MEMORANDUM

TO: BRYAN BLUNT, MANITOBA CONSERVATION
FROM: KARL-ERIC MARTEL, HELIMAX
SUBJECT: ST. JOSEPH WIND FARM ENVIRONMENTAL IMPACT STUDY - RESPONSE TO PUBLIC COMMENTS
DATE: JUNE 3RD, 2009
CC: KEITH KNUDSEN, ST. JOSEPH WIND FARM INC.

ST. JOSEPH WIND FARM PROJECT: RESPONSE TO PUBLIC COMMENTS

**MAP 1
REVISED PROJECT LAYOUT (130 WTGS)
AND EISR LAYOUT (200 WTGS)**

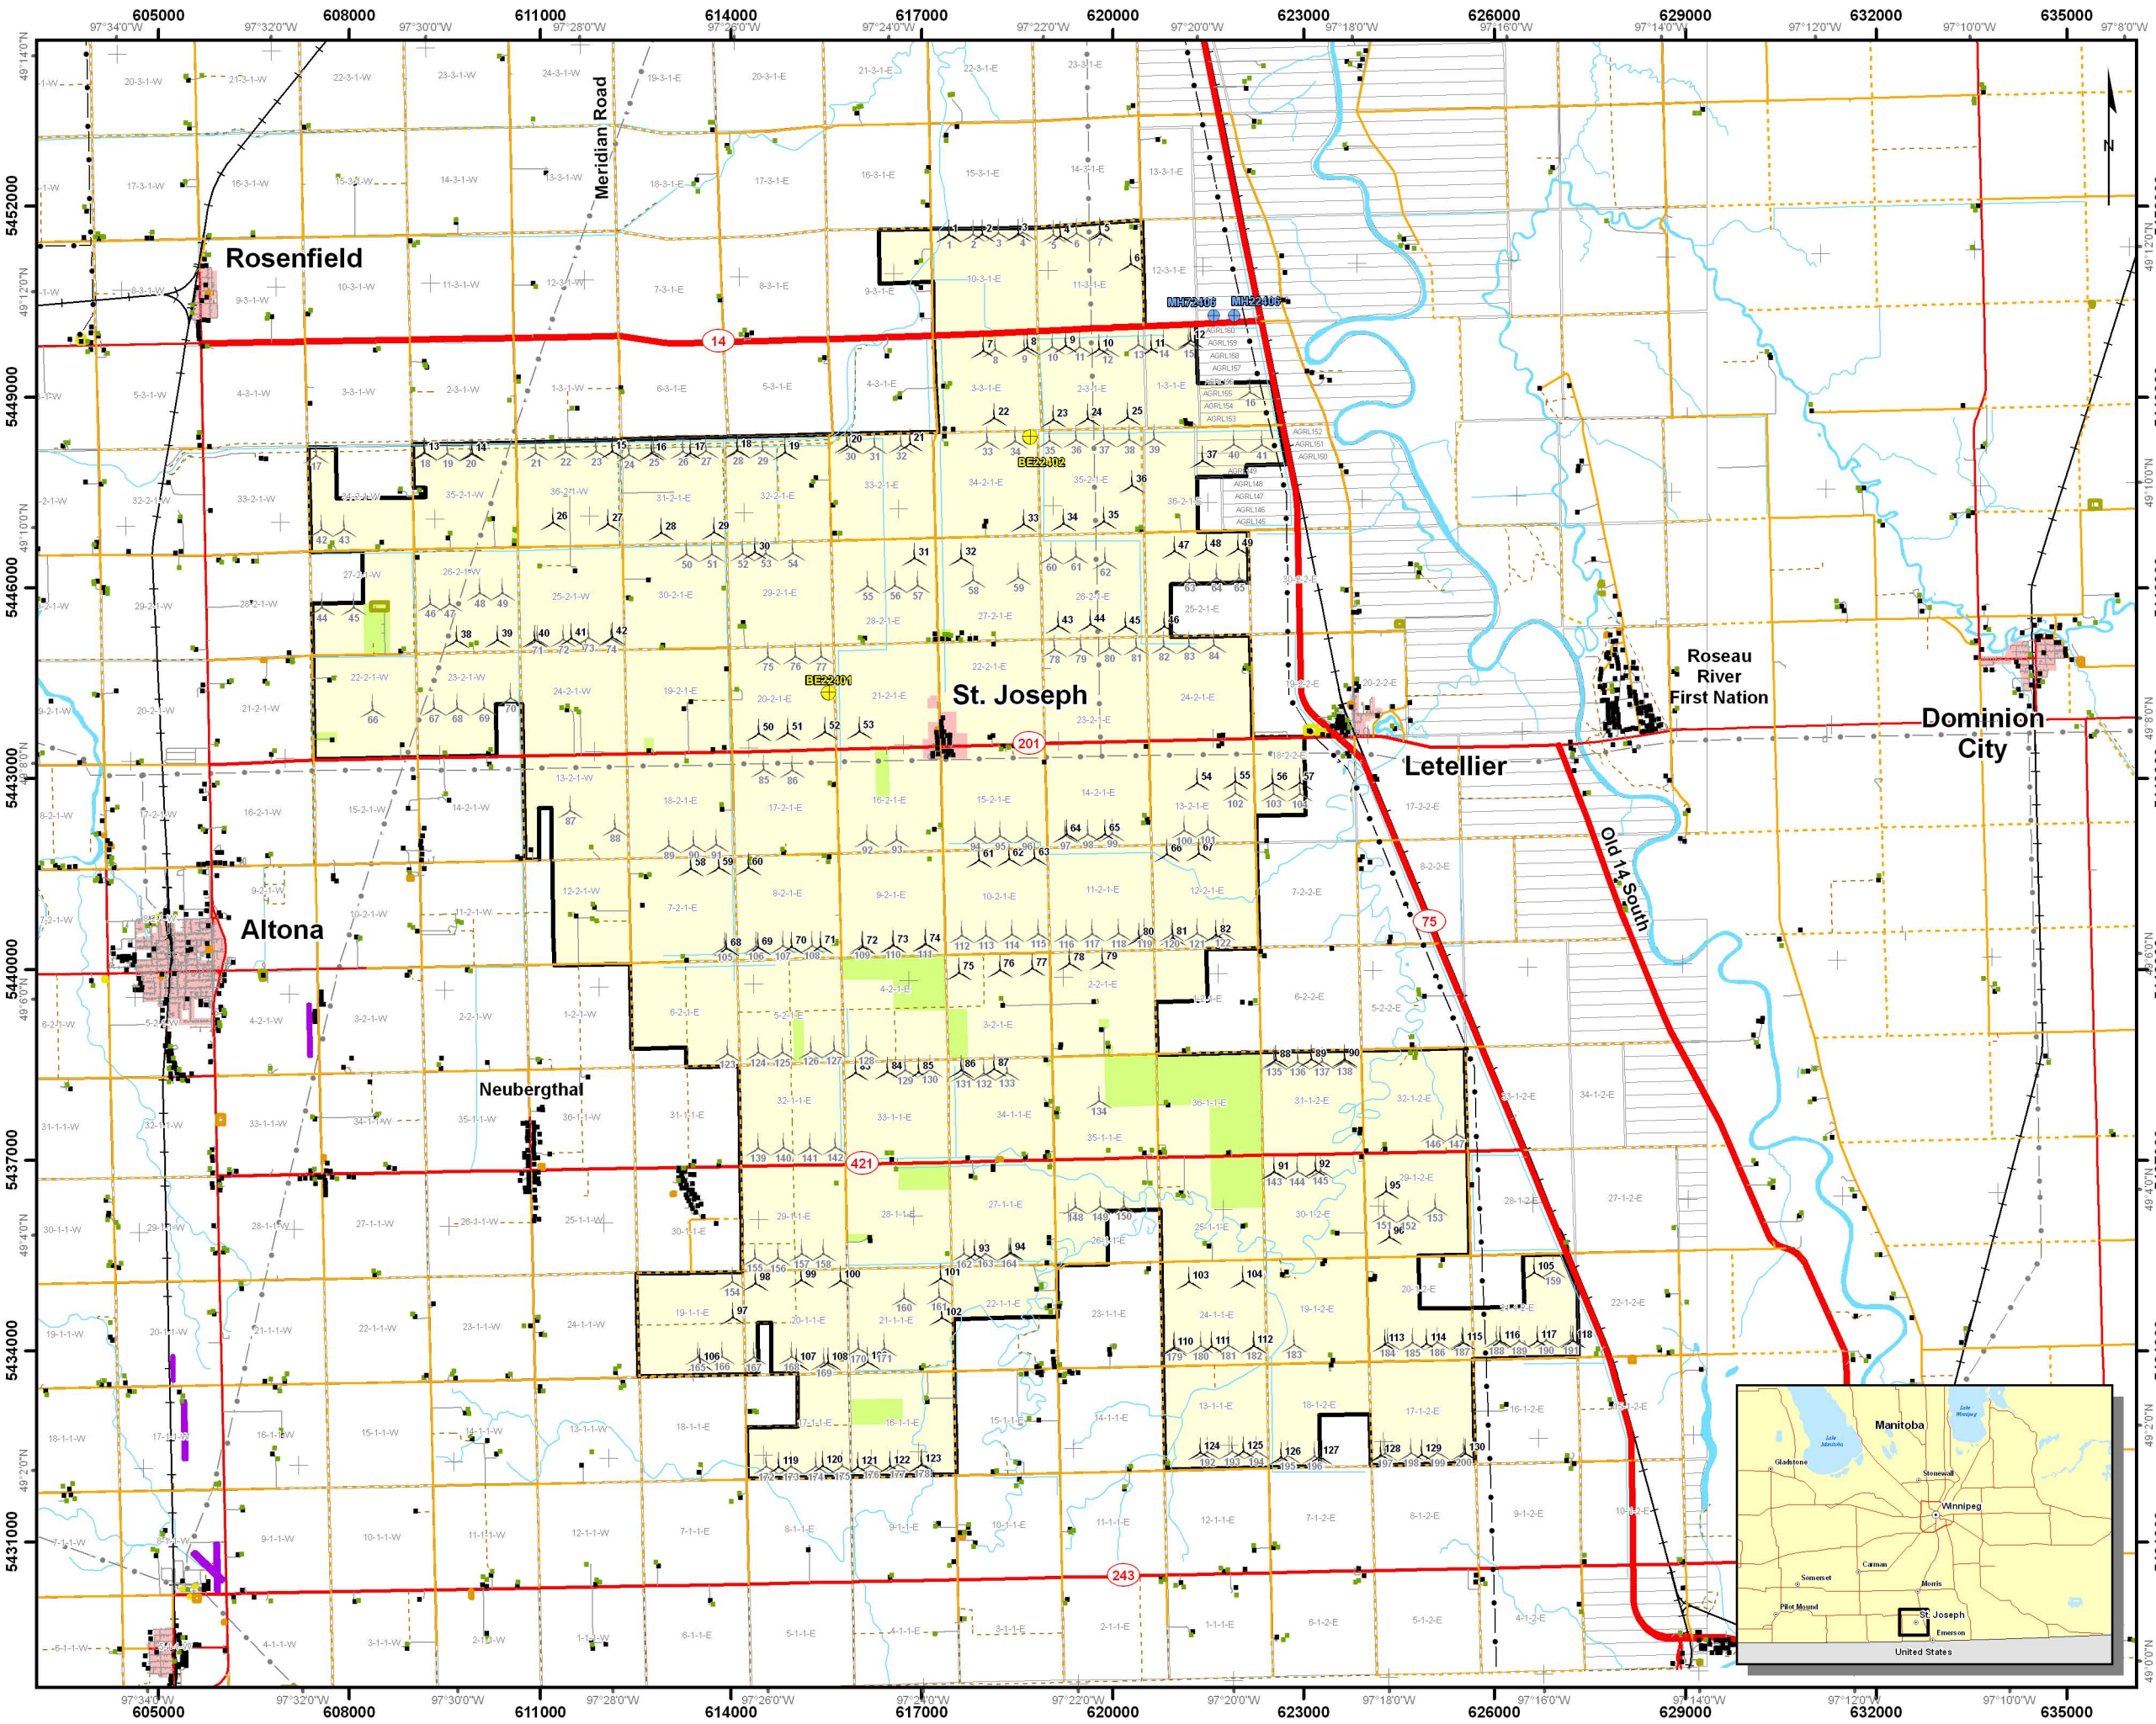
Specific concerns on the effects of the project on the landscape and the integrity of Neubergthal were expressed by Ms. Margruite Krahn.

Since the submittal of the EISR, the St. Joseph turbine layout has been revised due to a change in the wind turbine manufacturer and to further reduce any potential effects. Originally, as a worse-case scenario, a layout of 200 1.5-MW wind turbine generators was considered to assess the potential environmental impacts. These wind turbines were to be distributed over a surface area of approximately 215 km² of agricultural land. Since then, an agreement with Siemens was conducted and the Siemens SWT-2.3-101 2.3 MW wind turbine is now the model selected for the Project. This change, for the same nameplate capacity of 300 MW, brings the total number of turbines down to 130. The map attached illustrates the new layout as well as the former locations.

This issue has been addressed and is reflected in the revised layout. Furthermore, the turbine layout complies with all related requirements from Parks Canada.
